MSEX3034A-01

S E R V I C E N O T E

MSEX3034A – Oscilloscope, Mixed Signal, 4+8 Channel,
350MHz

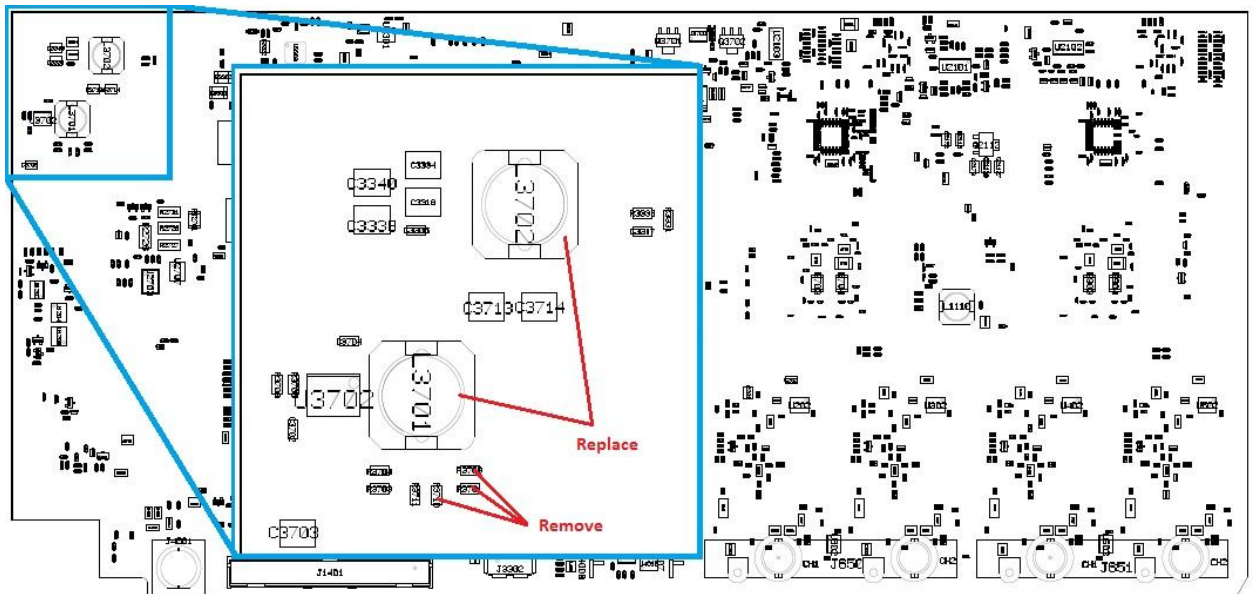
With the oscilloscope power turned on and while under normal operation, the unit emits a hissing noise.

2. As the picture indicates, remove the three resistors (0699-7209, 1 Ohm) located at R3701, R3709, and R3710. They are not to be replaced.
3. Remove as well the two inductors (9140-6474, 100uH) located at L3701 and L3702 and replace them with inductors with part number 9140-6151 (68 uH).
4. Re-assemble to the point where the unit could be powered up to verify that the hissing is indeed gone. If the hissing is not gone, please, check modifications.
5. When the hissing is gone, put oscilloscope back together.
